ZONING CONDITIONS FOR THE MERRITT RESERVE

CONSTRUCTION DRAWINGS FOR MERRITT RESERVE

PROJECT NUMBER = CID-25-XX

PRELIMINARY
PRELIMINARY
 NOT FOR USE FOR
 CONSTRUCTION
 FOR INFORMATION ONLY

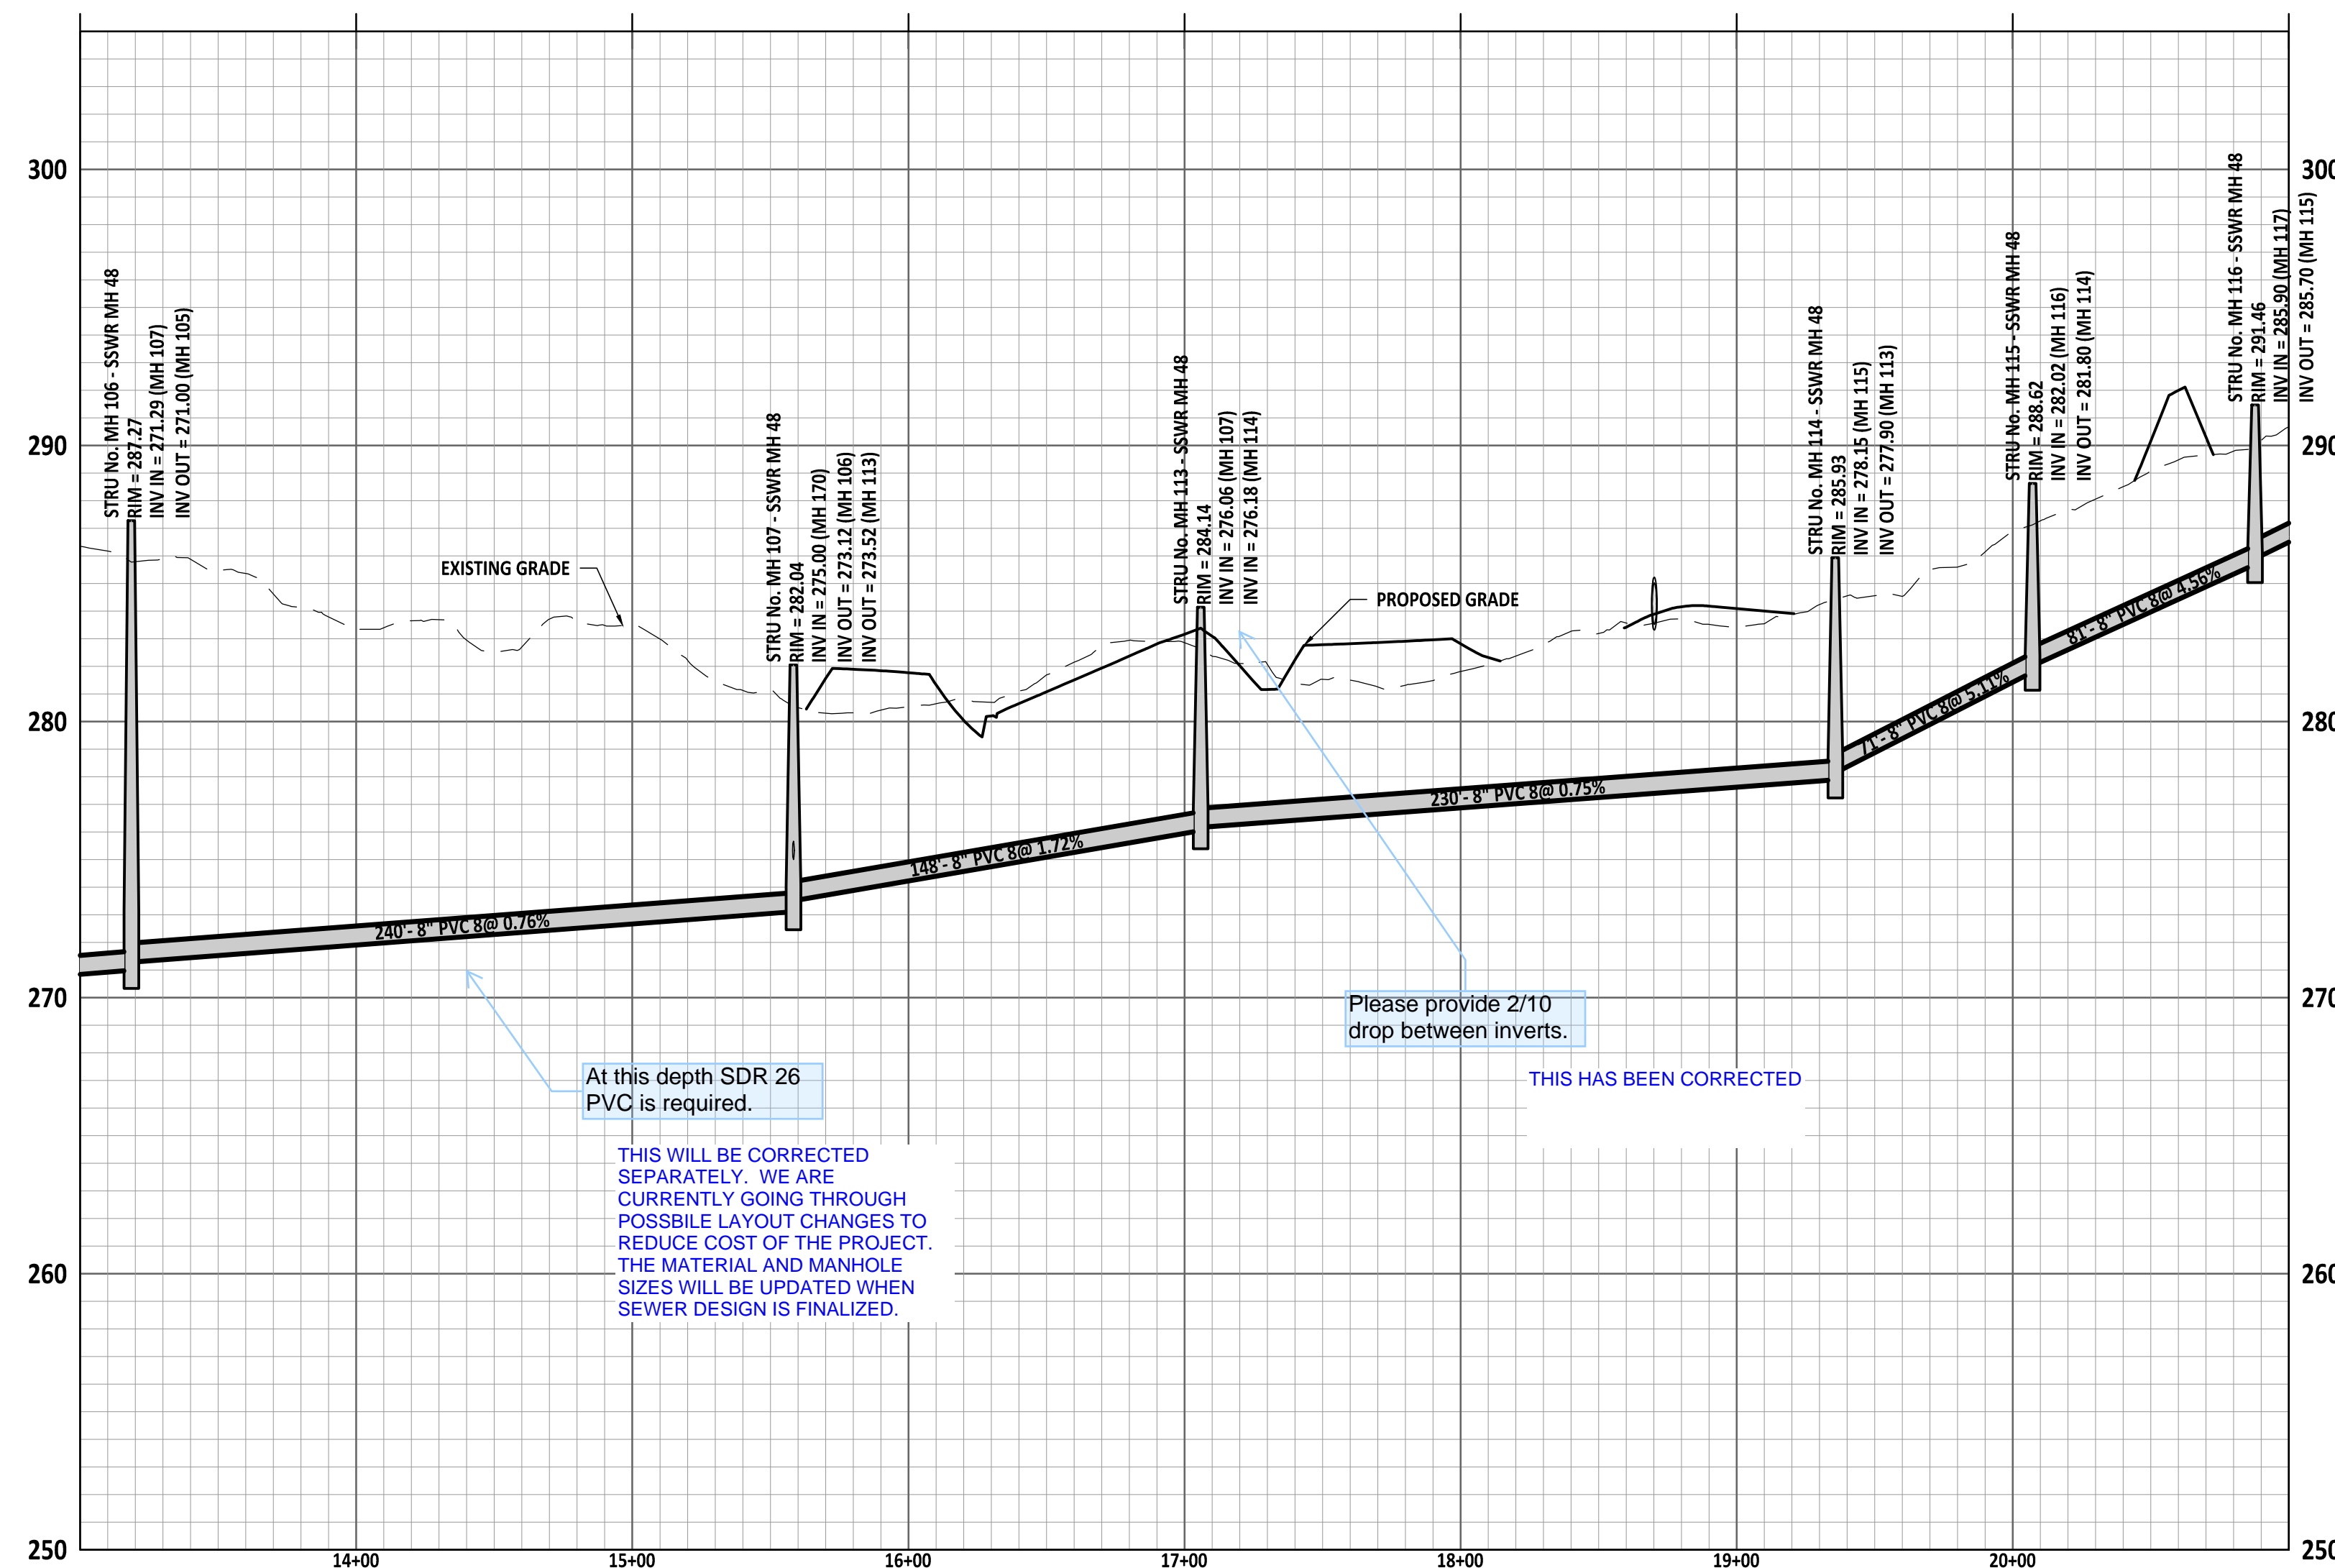
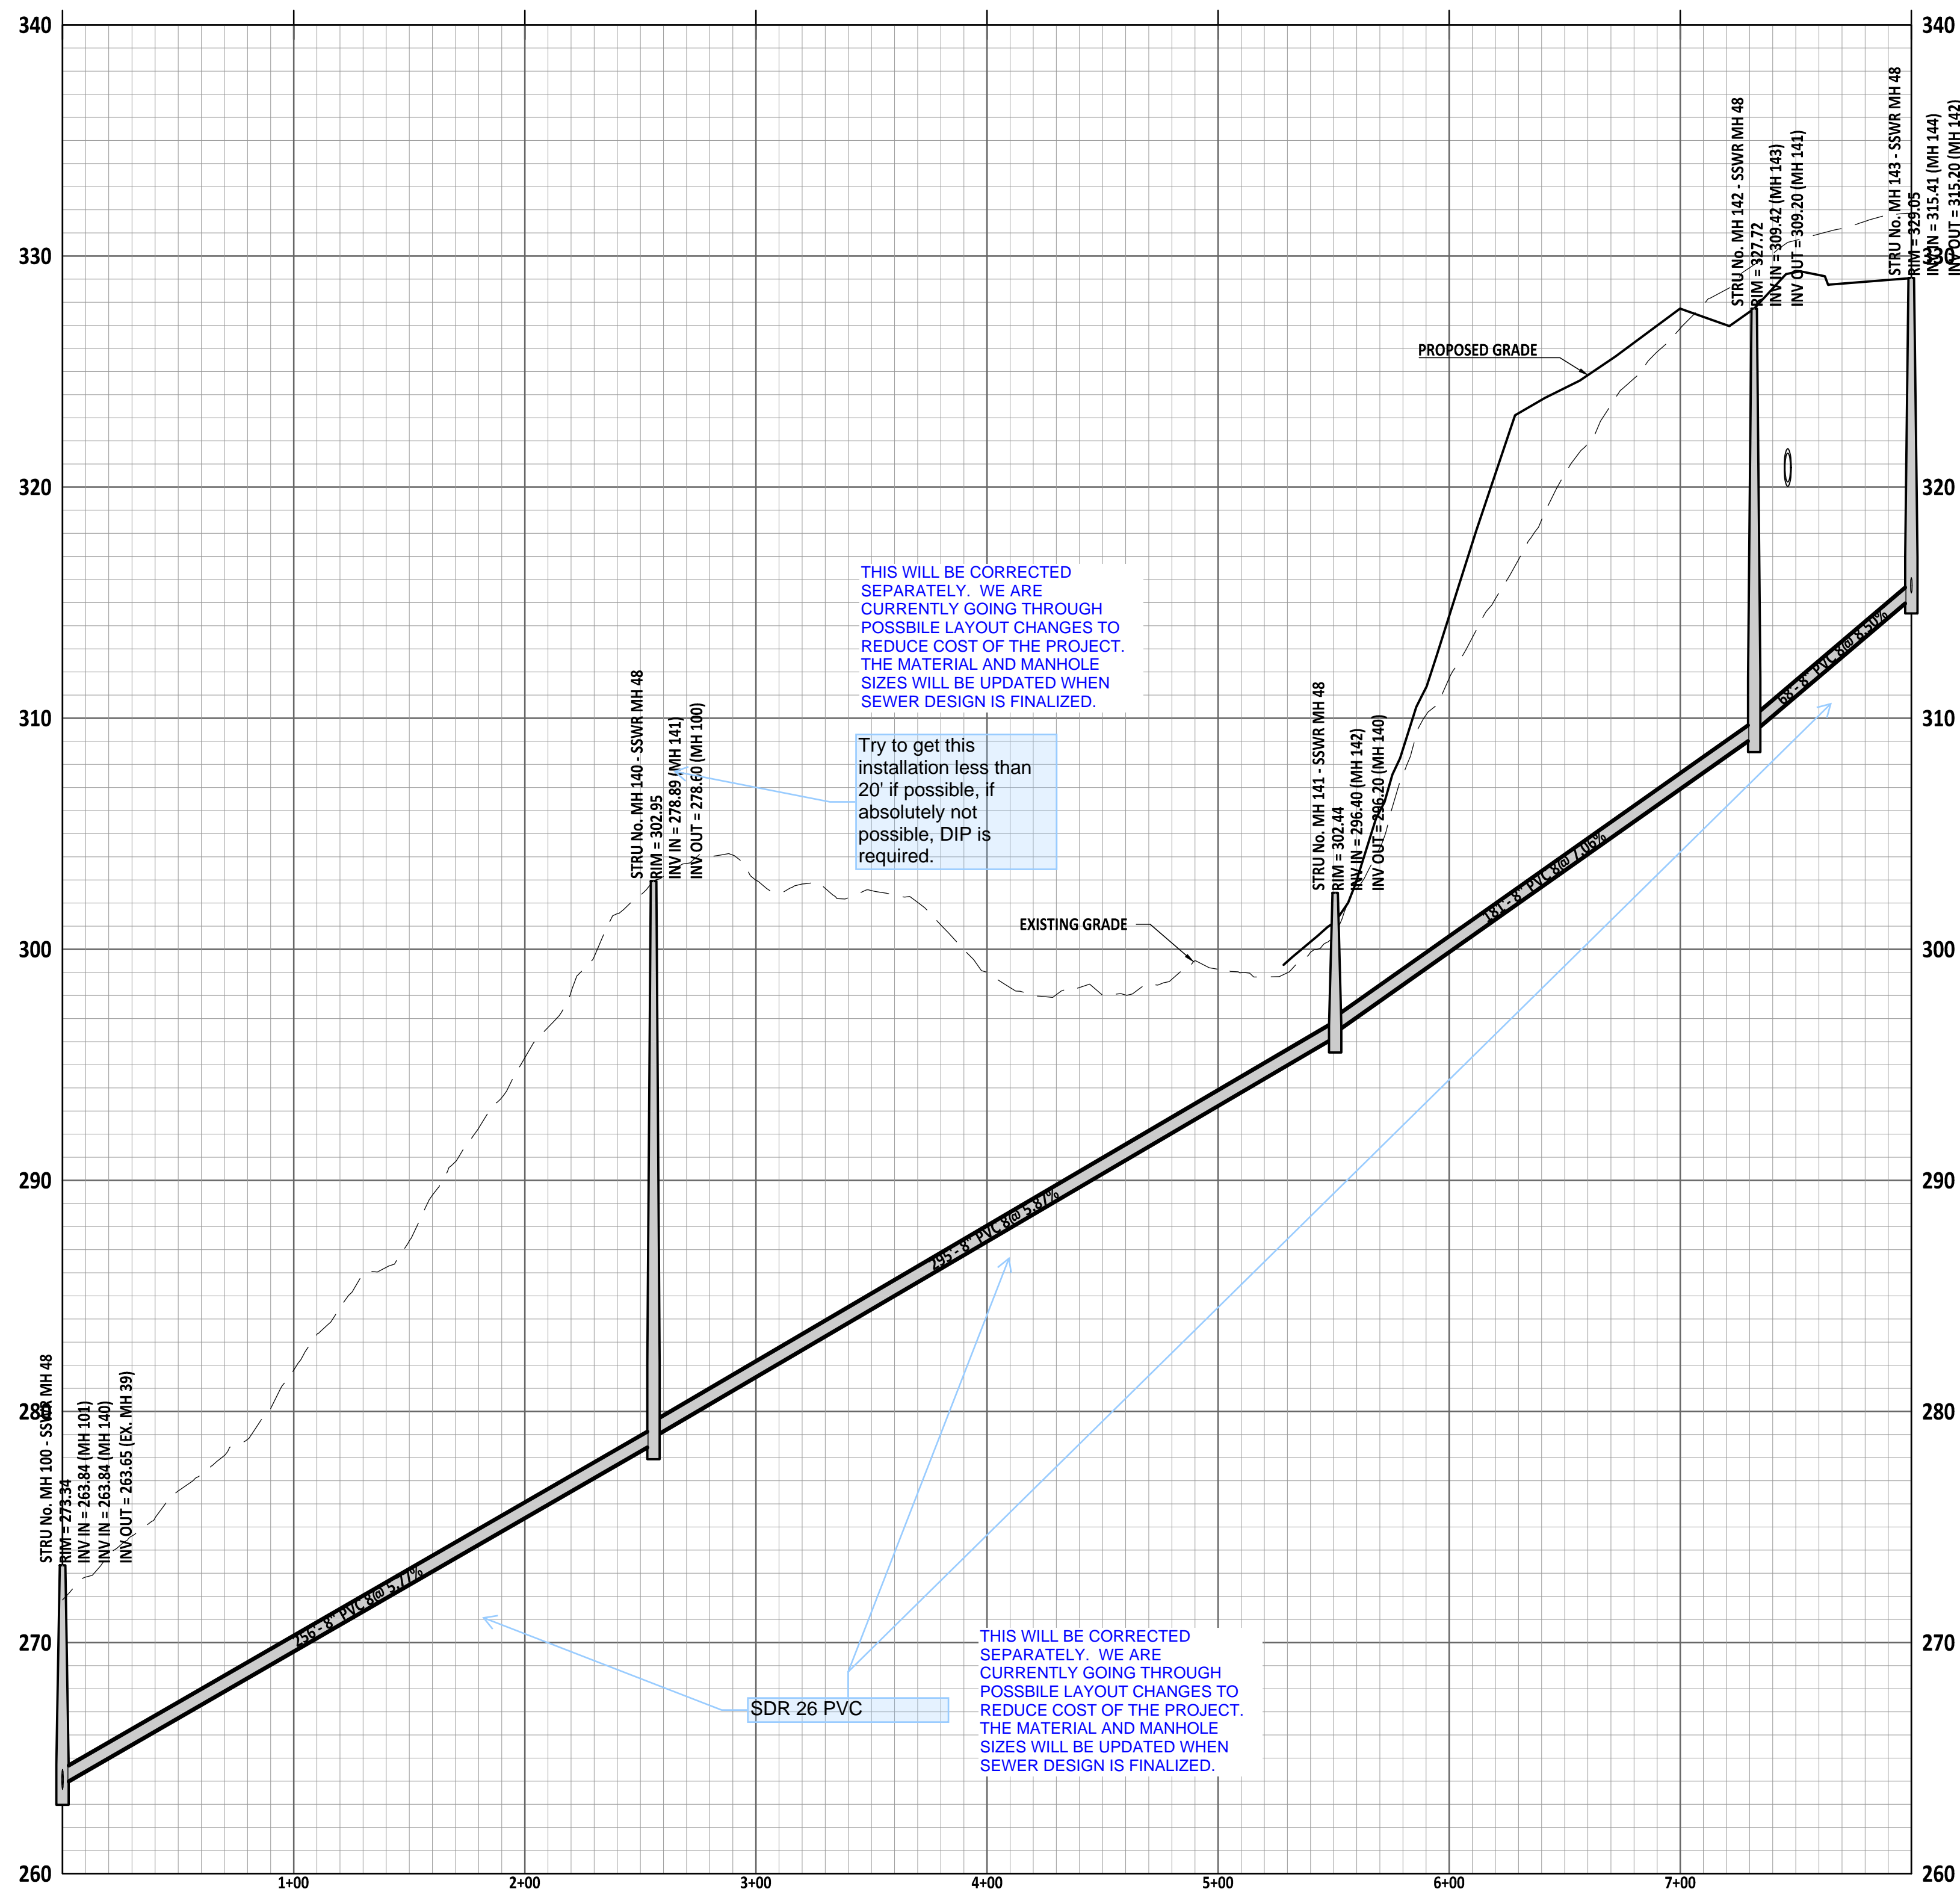
Must be DIP material at this depth. In fact, this main should also be installed within a casing at this depth for future maintenance.

Please call out all MH dia. If more than 12' installation depth, MHs must be 5' dia. If greater than 20' MHs must be 6' dia.

Try to get this installation less than 20' if possible, if absolutely not possible, DIP is required.

THIS WILL BE CORRECTED SEPARATELY. WE ARE CURRENTLY GOING THROUGH POSSIBLE LAYOUT CHANGES TO REDUCE COST OF THE PROJECT. THE MATERIAL AND MANHOLE SIZES WILL BE UPDATED WHEN SEWER DESIGN IS FINALIZED.

THIS WILL BE CORRECTED SEPARATELY. WE ARE CURRENTLY GOING THROUGH POSSIBLE LAYOUT CHANGES TO REDUCE COST OF THE PROJECT. THE MATERIAL AND MANHOLE SIZES WILL BE UPDATED WHEN SEWER DESIGN IS FINALIZED.

THIS WILL BE CORRECTED SEPARATELY. WE ARE CURRENTLY GOING THROUGH POSSIBLE LAYOUT CHANGES TO REDUCE COST OF THE PROJECT. THE MATERIAL AND MANHOLE SIZES WILL BE UPDATED WHEN SEWER DESIGN IS FINALIZED.

THIS WILL BE CORRECTED SEPARATELY. WE ARE CURRENTLY GOING THROUGH POSSIBLE LAYOUT CHANGES TO REDUCE COST OF THE PROJECT. THE MATERIAL AND MANHOLE SIZES WILL BE UPDATED WHEN SEWER DESIGN IS FINALIZED.
